DWG Procedure Manual Updates for NOGRR-245

Jonathan Rose
ERCOT Transmission Planning

IBRWG, Friday July 12, 2024

Summary of DWG Procedure Manual Edits

Section 3.1.5.4, LVRT setup

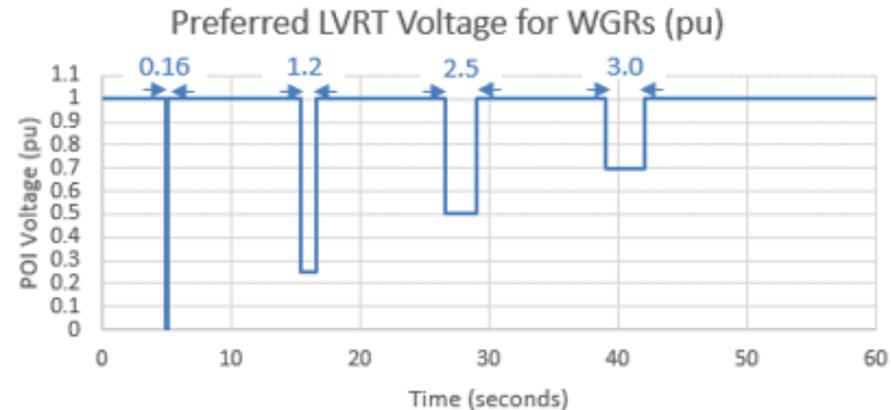
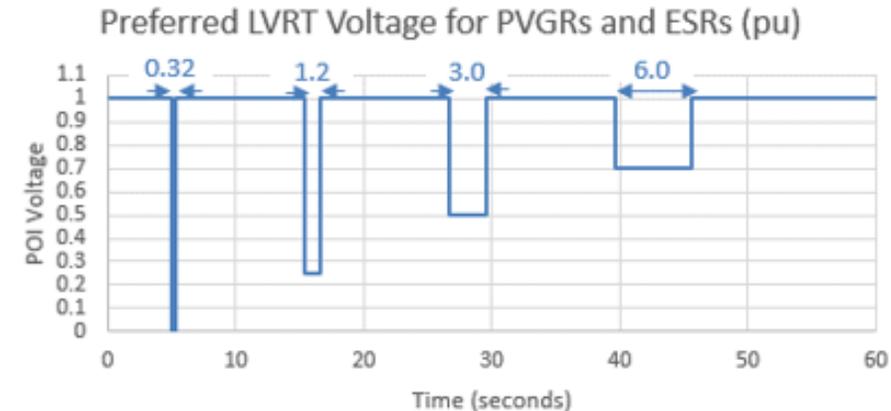
All IBRs, WGRs, and IBTEs -and WGR plants should test two curves, both a "legacy" curve and a "preferred" curve as described in NOG 2.9.1. Testing both curves helps provide important model performance information. In situations where passing the "preferred" curve is not mandated by NOG 2.9.1, the "preferred" curve test must be run but will be considered for informational purposes regarding owner efforts to maximize capability.

- The "legacy" Low Voltage Ride Through curve per NOG 2.9.1.2.
- The "preferred" Low Voltage Ride Through curve per NOG 2.9.1.1. The curve shall be run as a series of separate piece-wise disturbances with the voltage returning to 1.0 per-unit (pu) voltage after each disturbance (see below examples). The spacing between each disturbance may be greater than 10 seconds to allow for recovery as necessary.

- Requires testing of both Legacy and Preferred curves.
- Preferred curve run piece-wise.

Section 3.1.5.4, LVRT Criteria

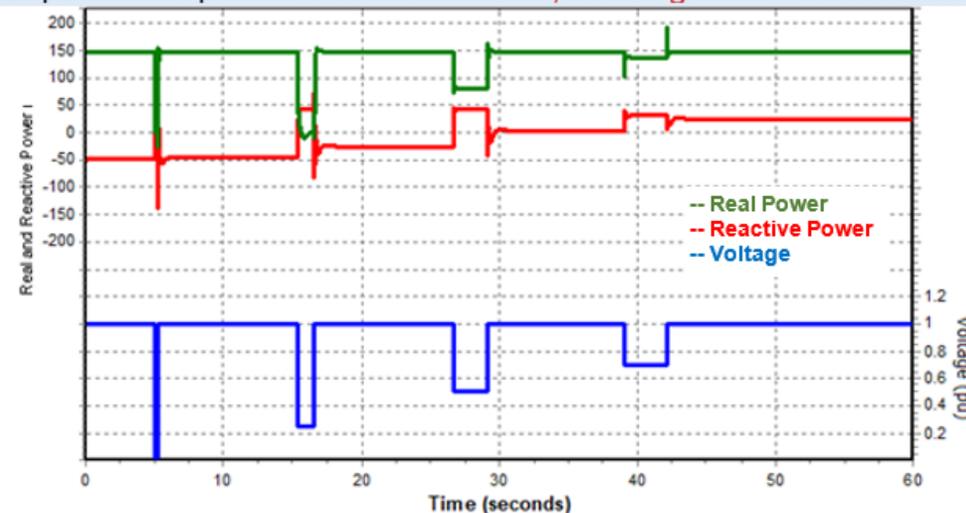
- For the low voltage transient, the model should inject reactive current throughout the voltage recovery period. At the POI, both P and Q are necessarily zero during zero voltage. Q injection at the POI should be observable immediately or very shortly after voltage begins ramp up from zero.
- For 0.9 pu sustained POI voltage, the AVR should provide voltage support that moves the resource towards nearly full reactive production (significantly lagging).
- Real power recovery should start prior to the POI voltage recovering to 0.9 pu.

Real power should recover to full output within 1.0 seconds of POI voltage recovery to 1.0 pu (typically 5% accommodation for sustained POI voltage dips provided real power is not in normal operation).

- During the voltage dips:
 - The model shall inject active current for POI voltage dips of 0.5 and higher.
 - Injections of significantly reduced active current for voltage dips 0.5 pu and 0.7 pu should be accompanied by increased reactive current.
 - Reactive current injection at the POI shall be observable immediately or very shortly after a non-zero voltage dip is applied.
- After the voltage dips:
 - Real power should recover to full output within 1.0 seconds of POI voltage recovery to 1.0 pu.
- An explanation, including a reference to any exempt status per ERCOT Nodal Operating Guide Section 2.9.1, shall be provided for models which indicate that the unit trips or fails to meet any of the above performance criteria.

- Legacy curve performance criteria unchanged
- New performance criteria for preferred curve.
 - Note that these borrow heavily from the existing requirements and are mostly updated because the piecewise nature of the test is different from the Legacy curve.

Section 3.1.5.5, HVRT setup

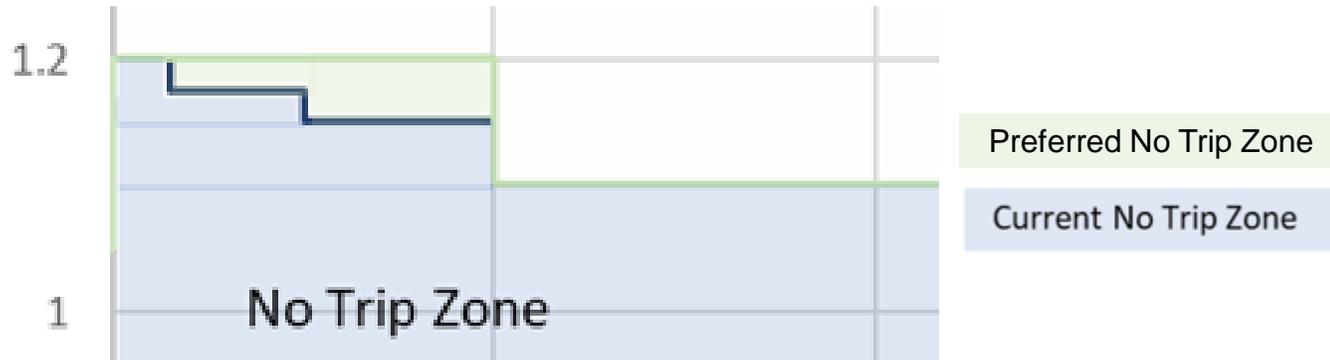
First, apply the "preferred" HVRT curve to the POI per NOG 2.9.1. If the facility cannot meet the "preferred" ride through requirements, then additionally test the "legacy" HVRT curve and report both results. The "preferred" curve has more stringent requirements, so it is not necessary to test the "legacy" curve for devices passing the "preferred" curve, and such testing would generally not provide additional revelations regarding model behavior.

- Run the new preferred curve. If unacceptable, then run the Legacy curve.
- HVRT model performance criteria unchanged
